AGENDA OF THE PLANNING COMMISSION  
SPECIAL MEETING  
CITY OF BIRCHWOOD VILLAGE  
WASHINGTON COUNTY, MINNESOTA  
March 6, 2025  
6:45 P.M.

**Meeting Date(s):** February 27, 2025 Planning Commission  
March 11, 2025 City Council

Report prepared by Ben Wikstrom, Planning Consultant

**GALATOWITSCH RESIDENCE - HARDSCAPE & FLOW**  
131 WILDWOOD AVE. WHITE BEAR LAKE, MN 55110

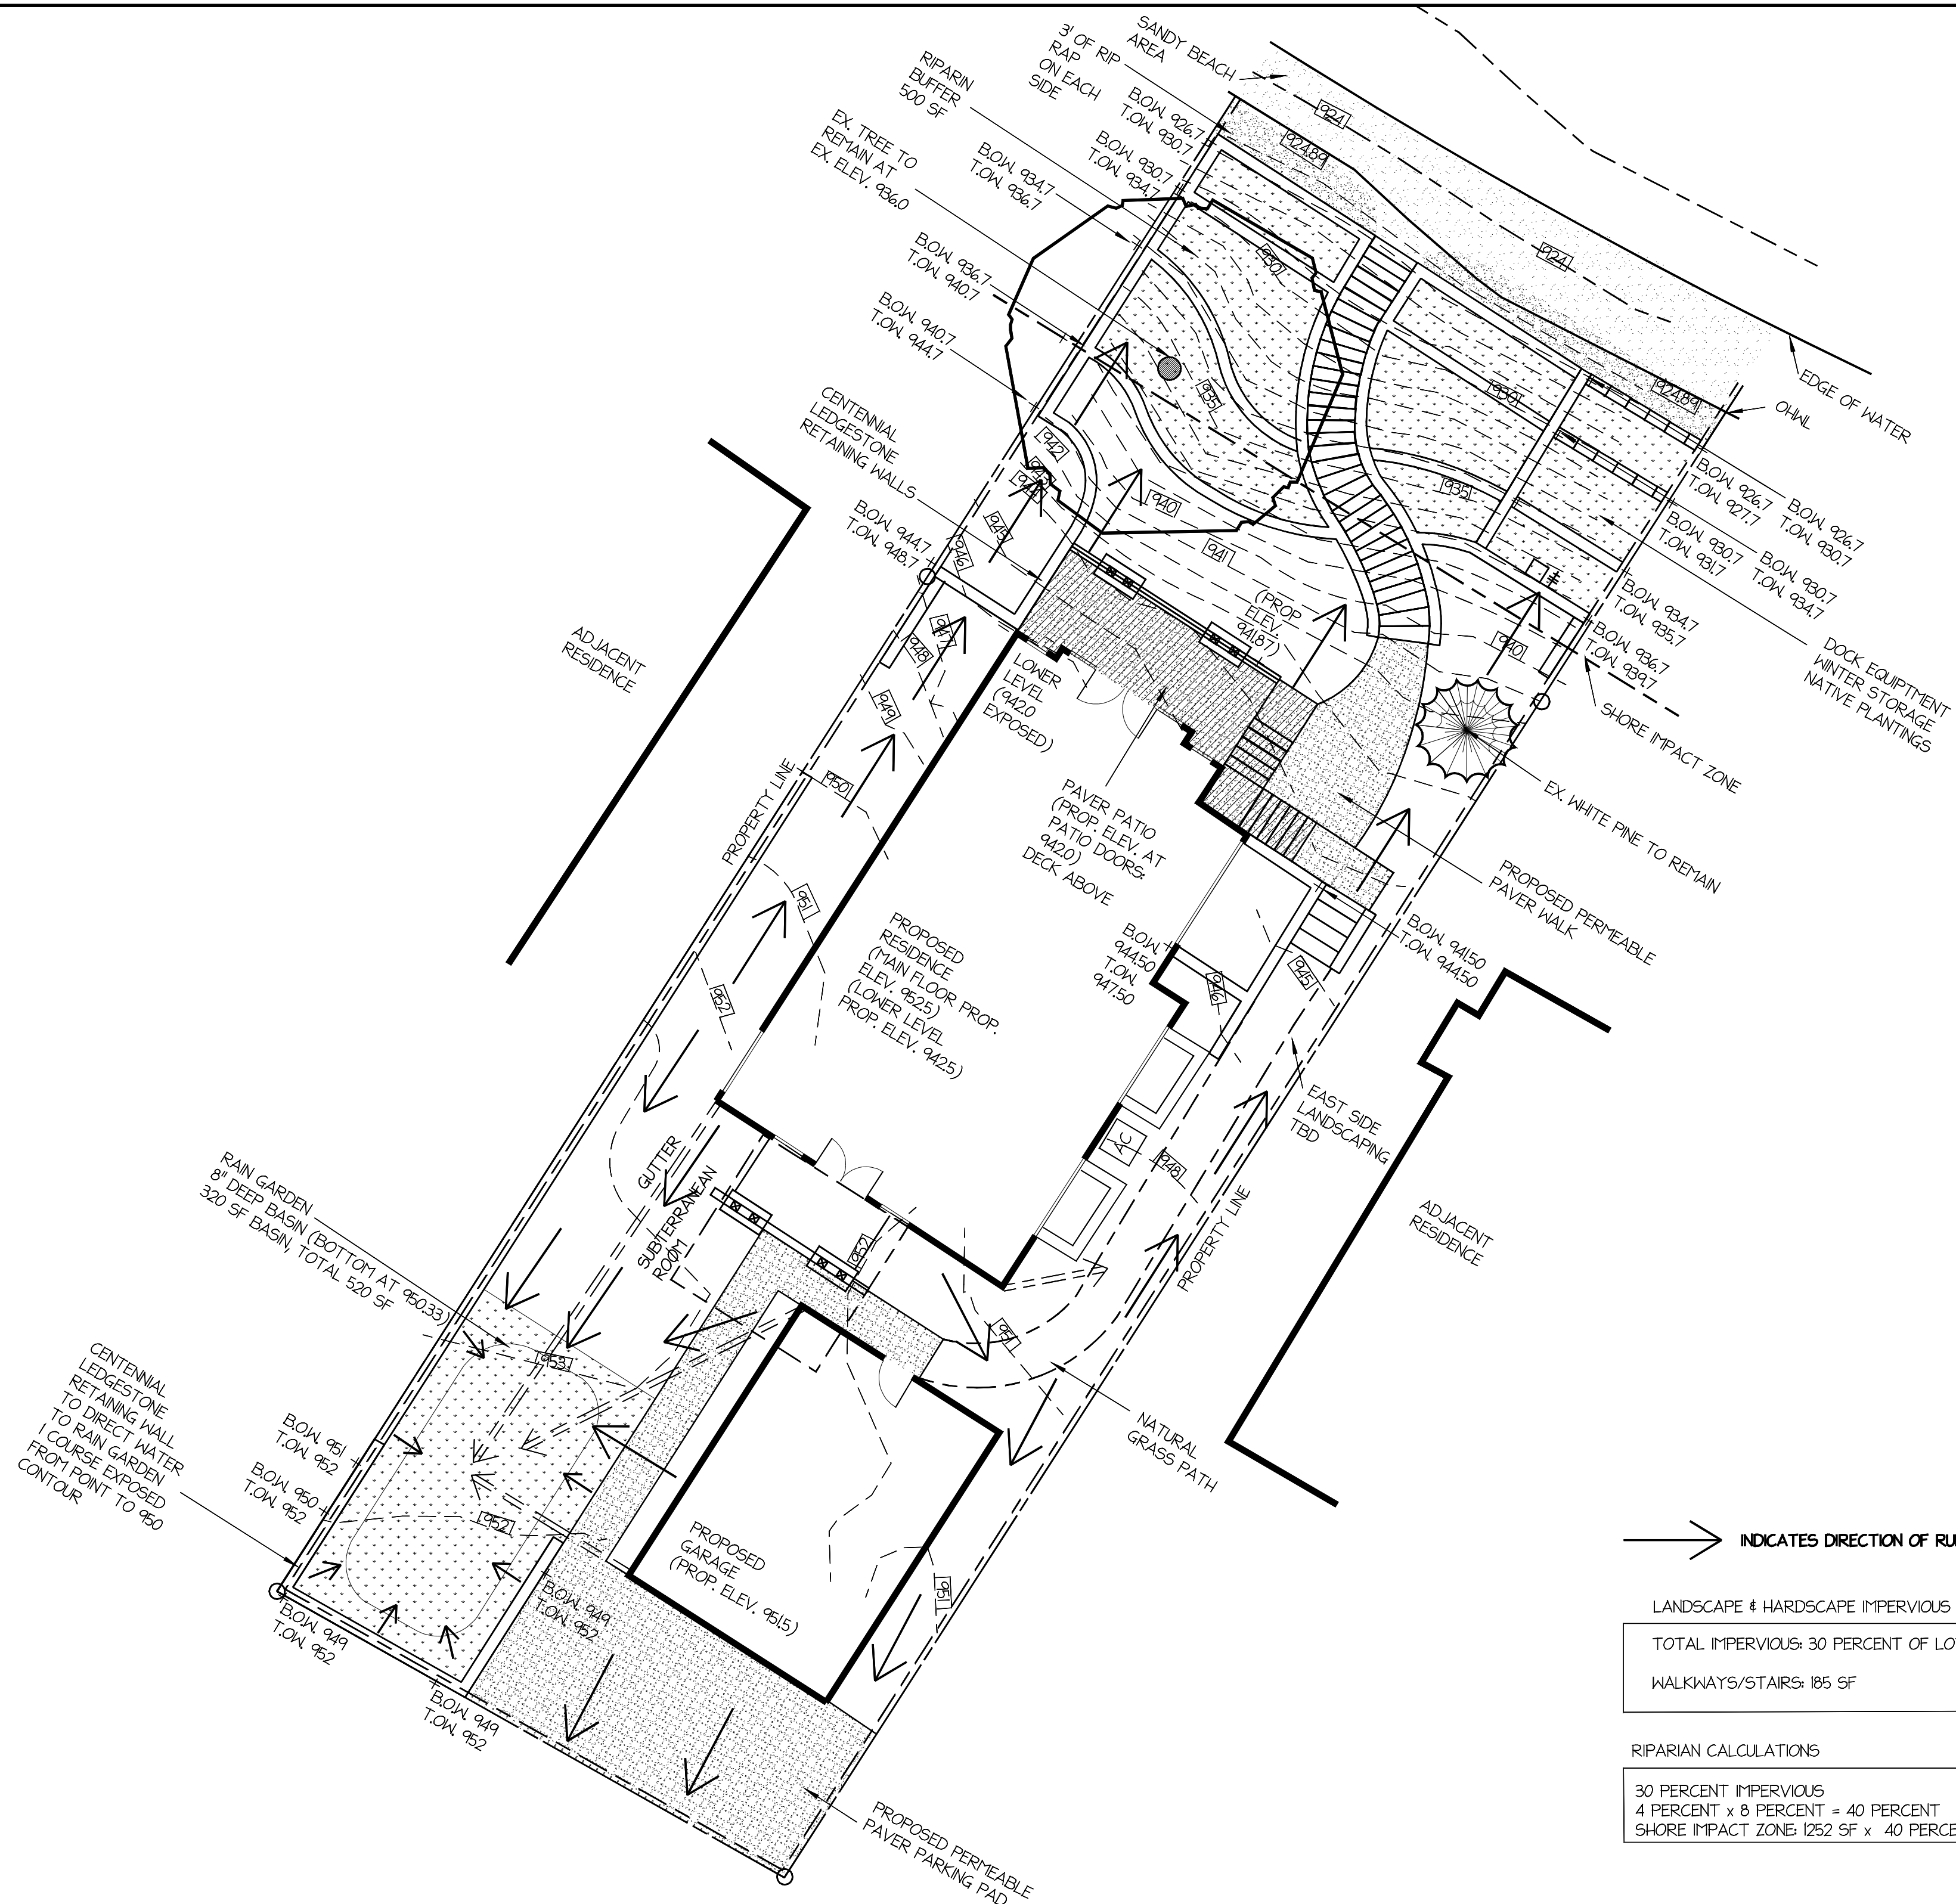
Staff comment

It appears from the proposed landscape and hardsurface plan that all requirements for buffer areas and impervious mitigation will be met with this plan; it will be further reviewed by the Planner and Engineer to ensure compliance with the impervious allowance of 25-30%. This variance is necessary to allow construction of the walls within the OHWL setback area. More detail is available on the attached plan, while discussion of the design of this area should occur at the meeting(s). Staff does not see a problem with the proposed design, and it is similar to other tiered yards along the shoreline; whether other options are available is not known, but the proposal seems reasonable and in keeping with the spirit and intent of the ordinance.

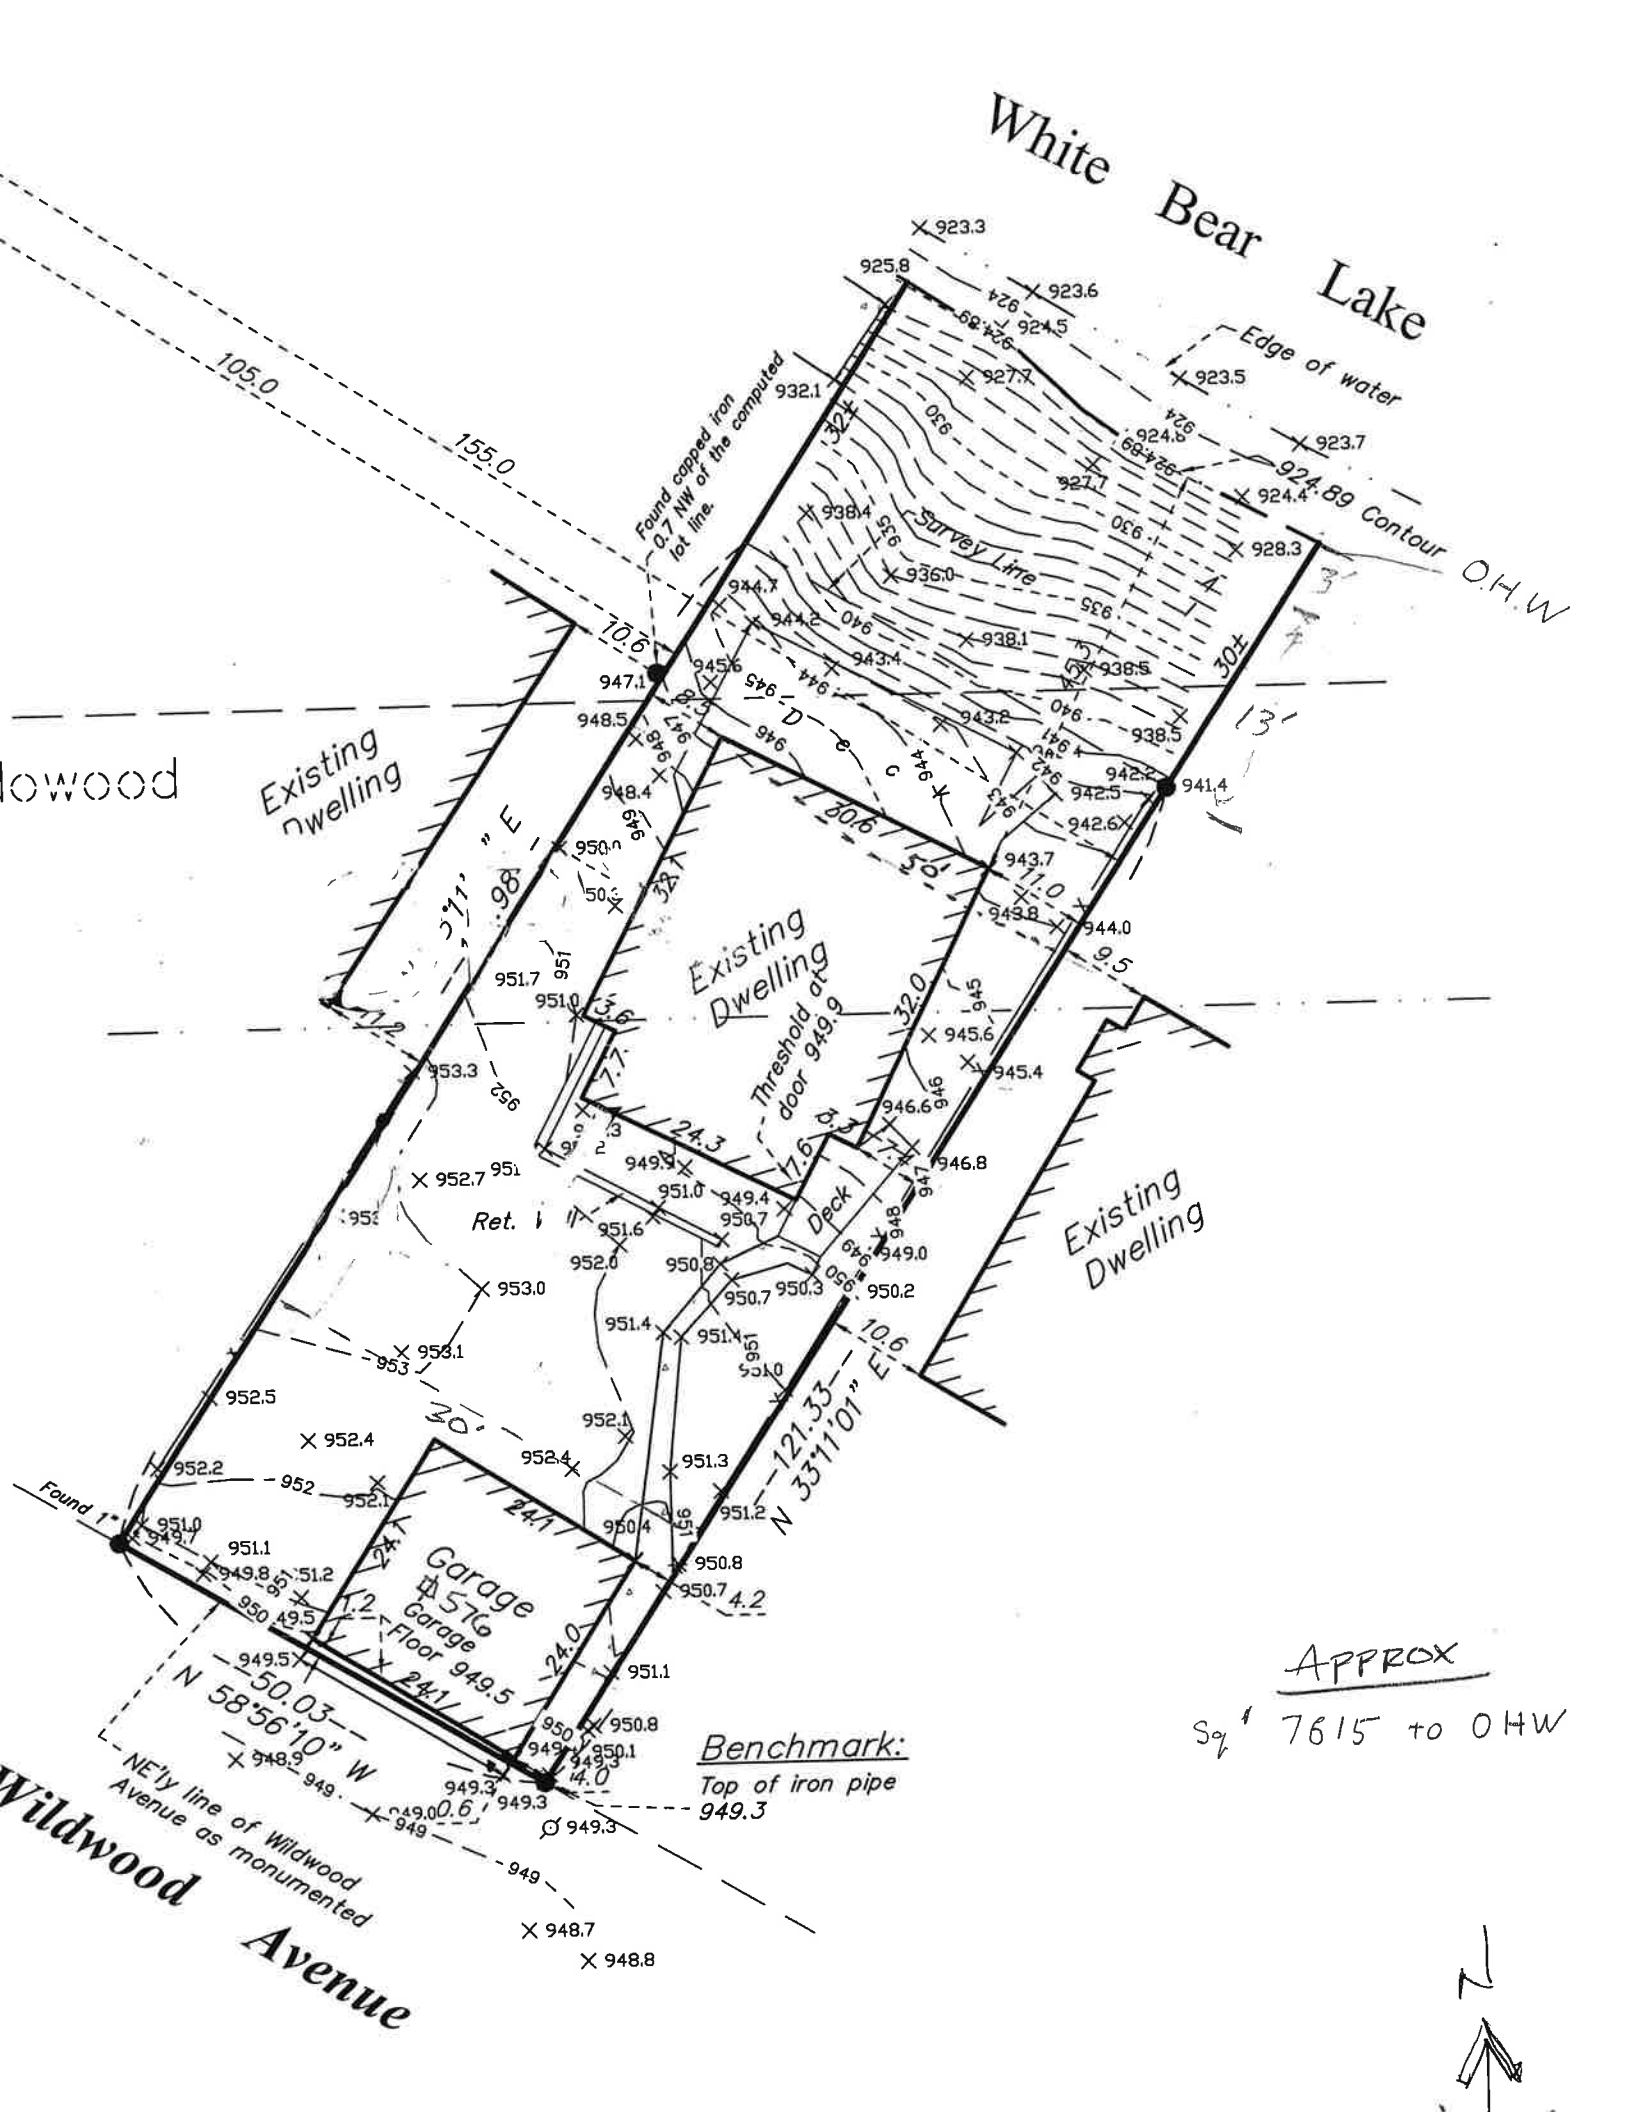
One item that should be discussed at the meeting, beyond those things mentioned above, is the deck on the lake side. The previous posts are evident on the survey, and this has been discussed with the applicant, but staff would like a better understanding of the plans (to ensure that another variance isn't needed, as much as anything) and how they relate to the previous structure; the OHWL setback for decks has been a contentious issue for the City.

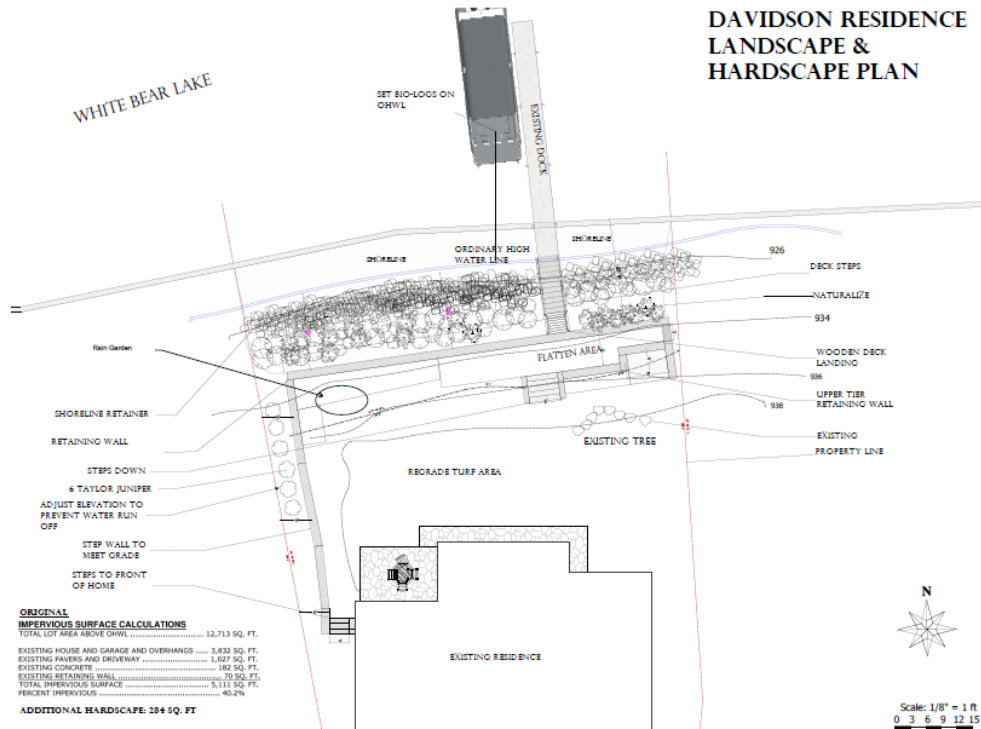
The applicant is proposing to construct the retaining wall to mitigate erosion problems that are occurring on site. The area of impact is shown on the pictures below, followed by a rendering of the site and wall.

Some clarification will be needed from the applicant regarding the changes in proposed materials, as well as the tiering of the wall and locations. The plan submitted is shown here (as always, see the attachments for a clearer depiction):
